City of Chipley
Planning & Zoning Commission Meeting
November 19, 2026 at 3:00 PM
City Hall - 1442 Jackson Avenue, Chipley, FL 32428
AGENDA

1. **Request for Development Order** - Wal-Mart Stores East LP - 1621 Main Street

MEETING DATE	PREPARED BY
Thursday, November 19, 2026	Tamara Donjuan, Planning & Zoning Officer

Wal-Mart Stores East LP is requesting a development order for proposed expansion and renovations. This property is zoned Commercial and is within the Corridor Development District (CDD) overlay, which requires review and approval by the Planning and Zoning Commission and the City Council. The property is located at 1621 Main Street, Parcel ID: 00000000-00-2336-0000, 28.46 Acres.

SHEET: C0.1

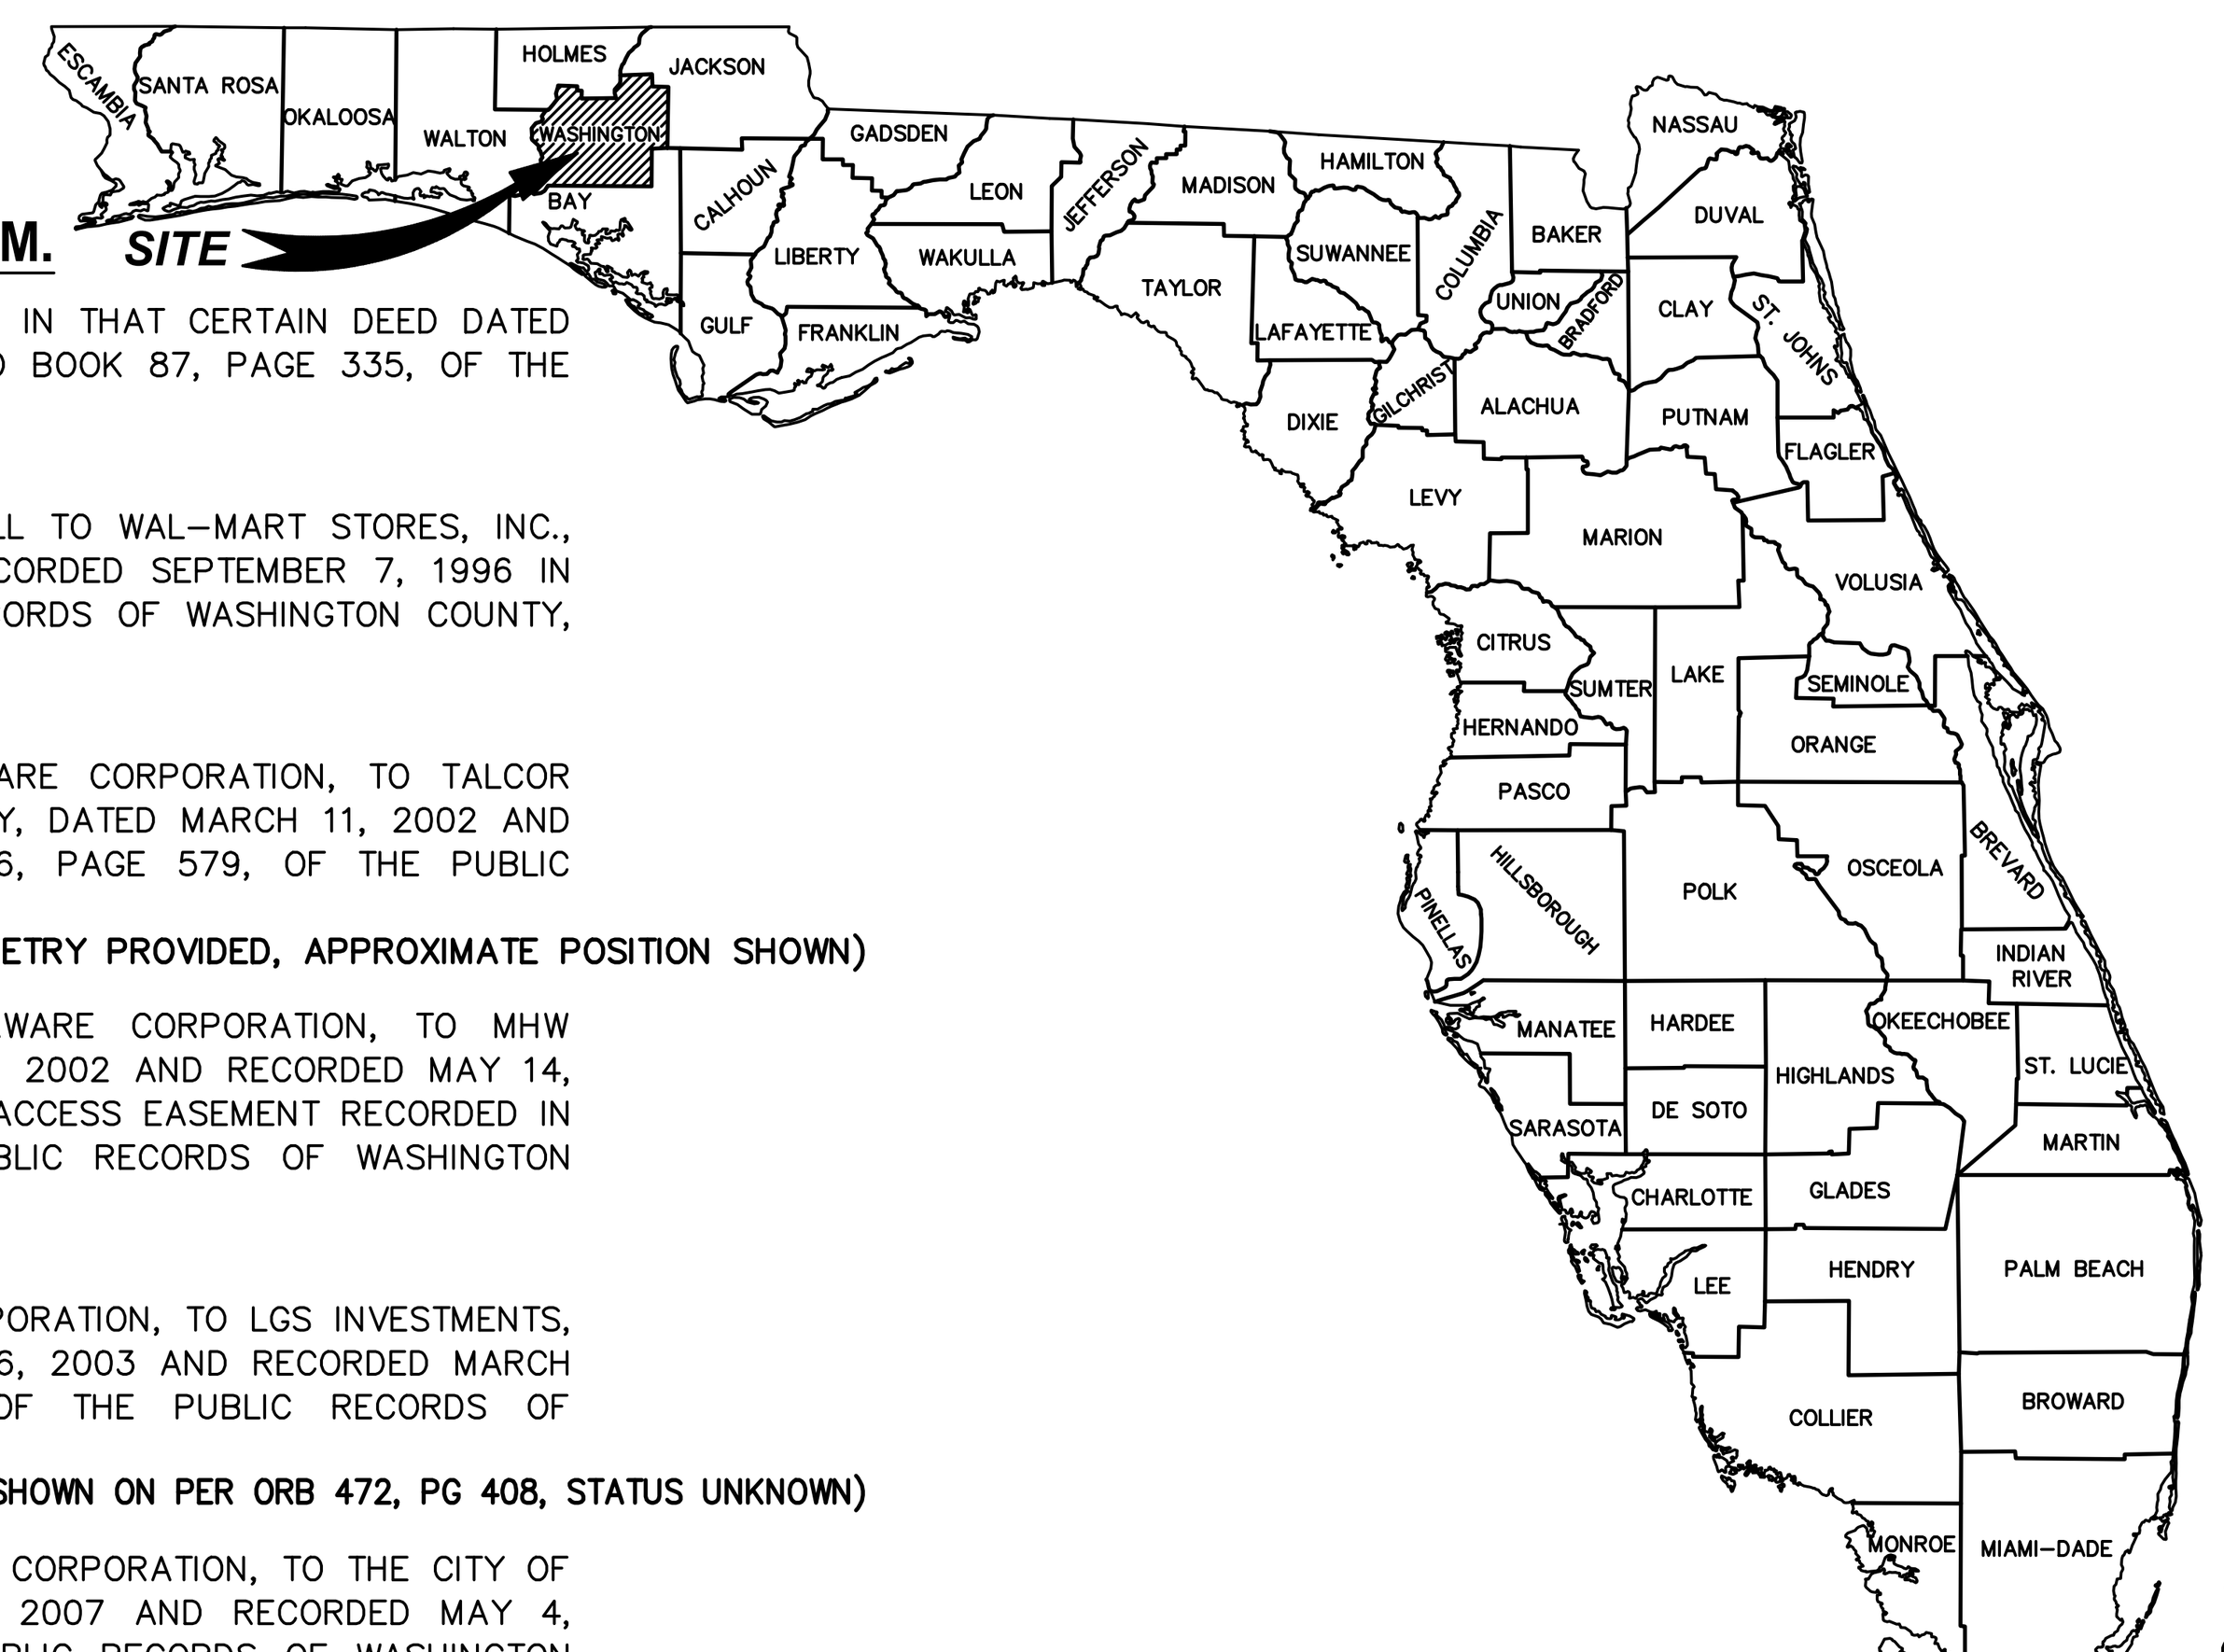
Sufficient: Provided in Plan Set: C0.1 & V0.1.

Sufficient: This subsection may be required by zoning commission but is provided in the Cover page of the Plan Set.

SHEET: C1.0

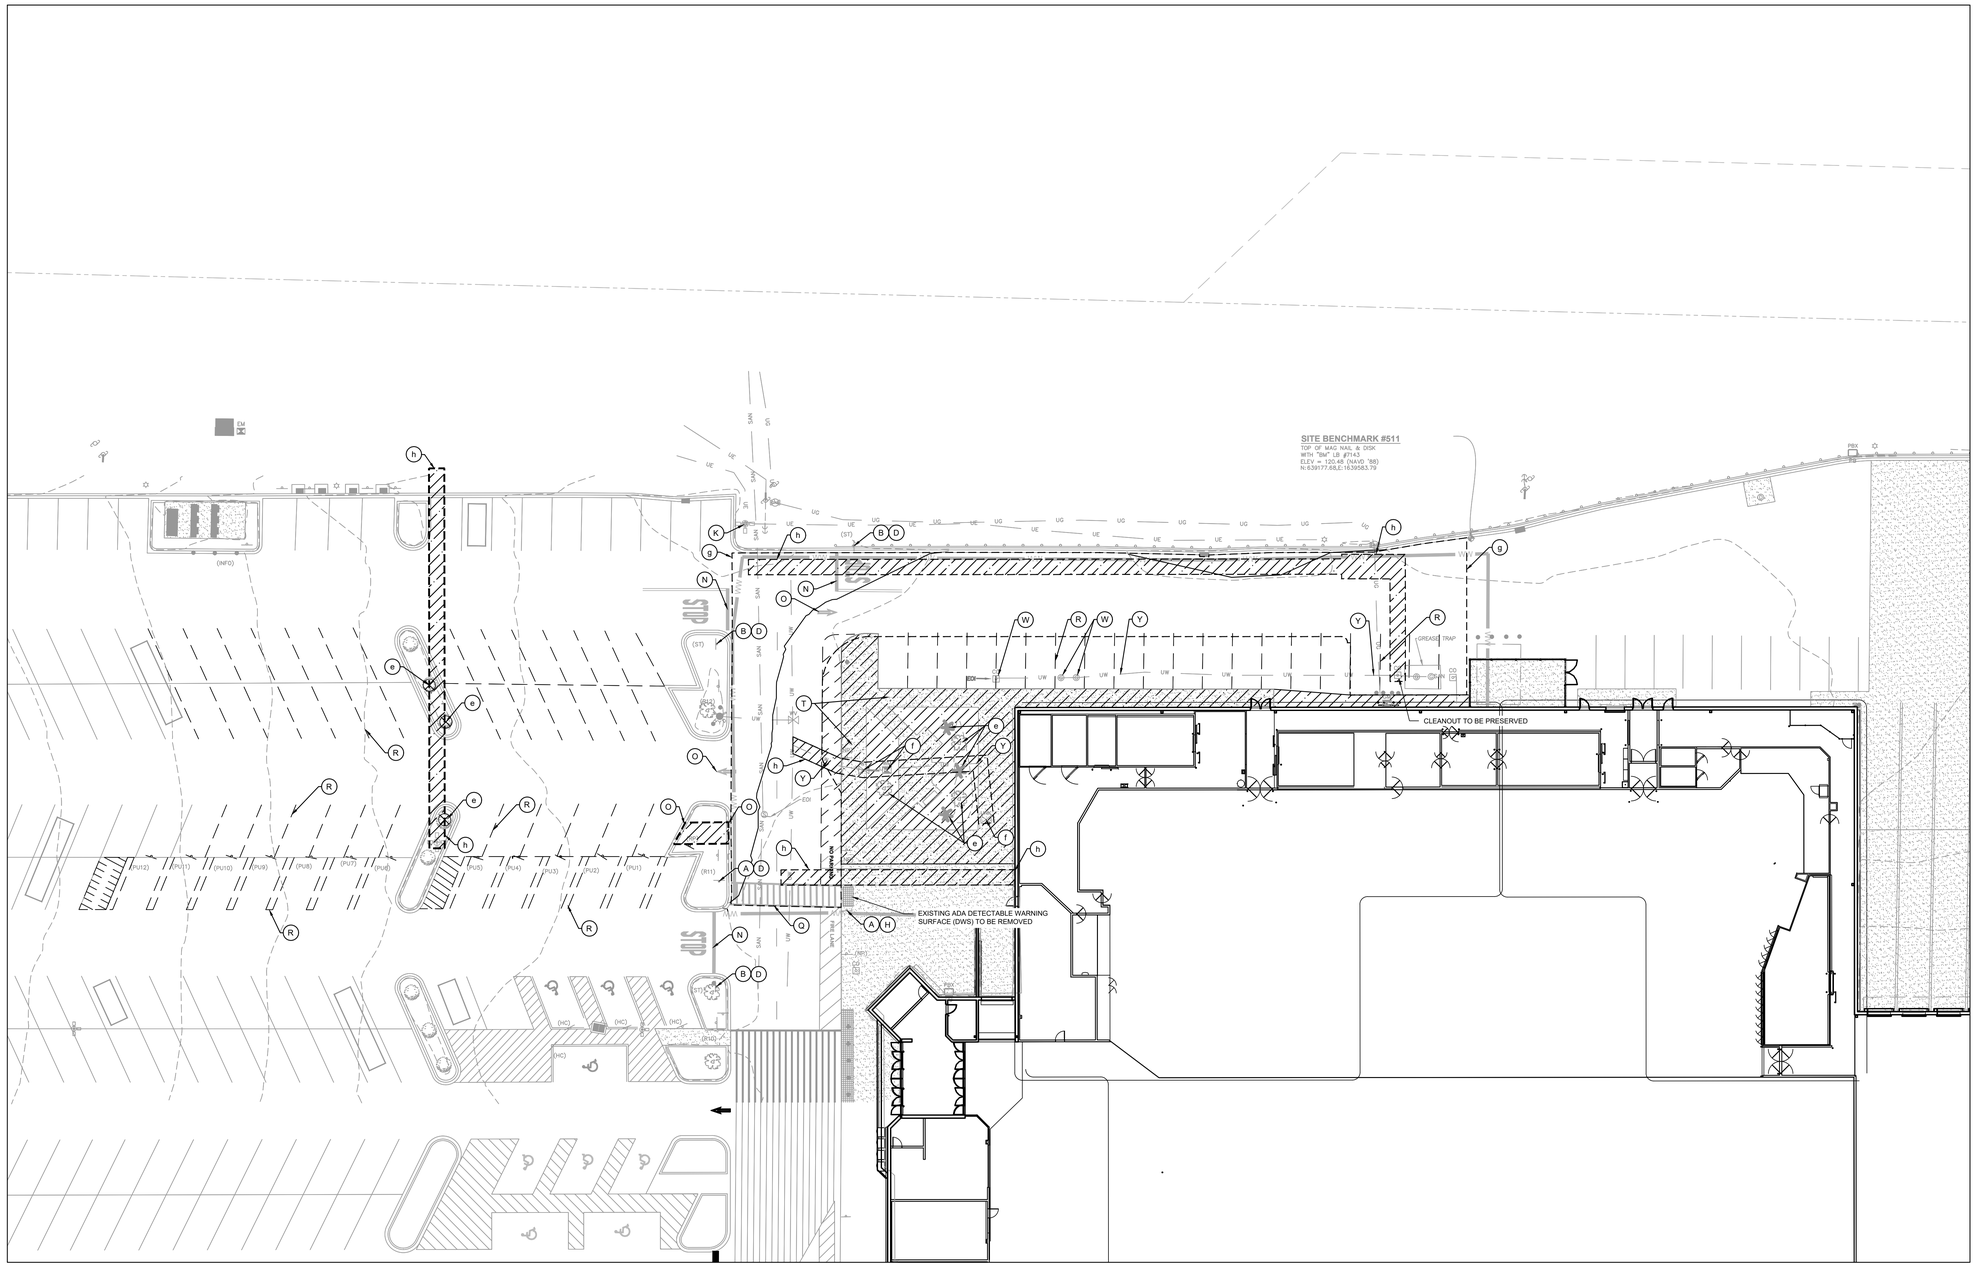
Sufficient: This subsection may be required by zoning commission but a Stormwater Management Plan is provided C1.0 & C5.4.

SHEET:
C1.2

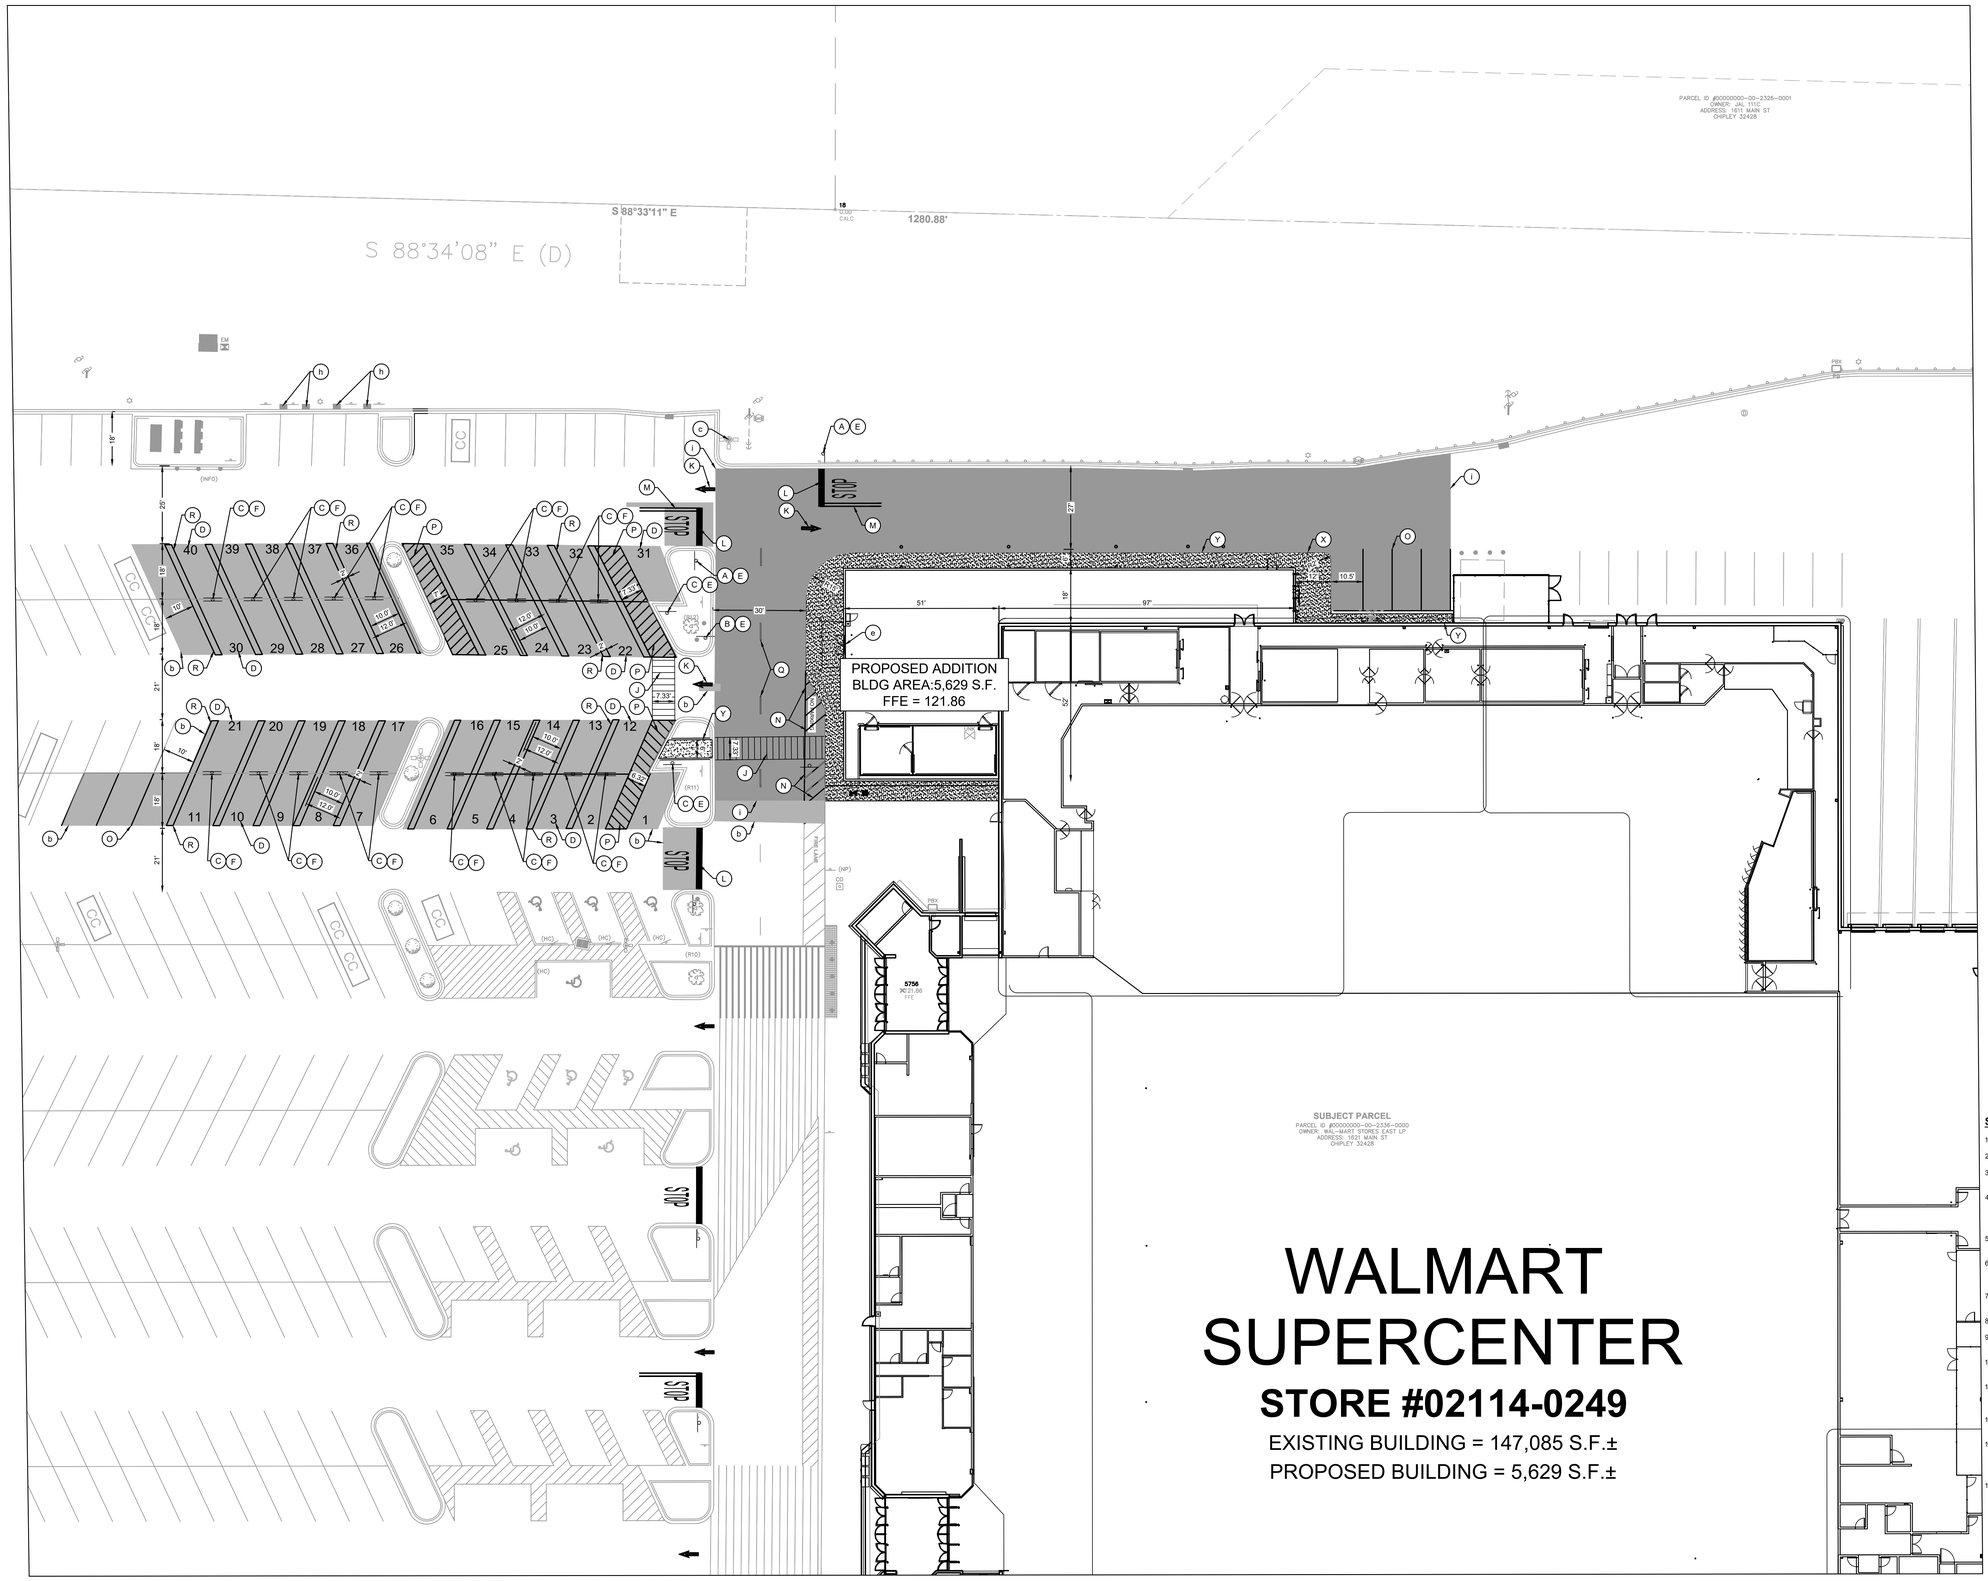
Sufficient: The proposed front setback is 700 feet, according to Plan Set Sheet C1.2. **For commercial zoning there are no side and rear setbacks are required.**
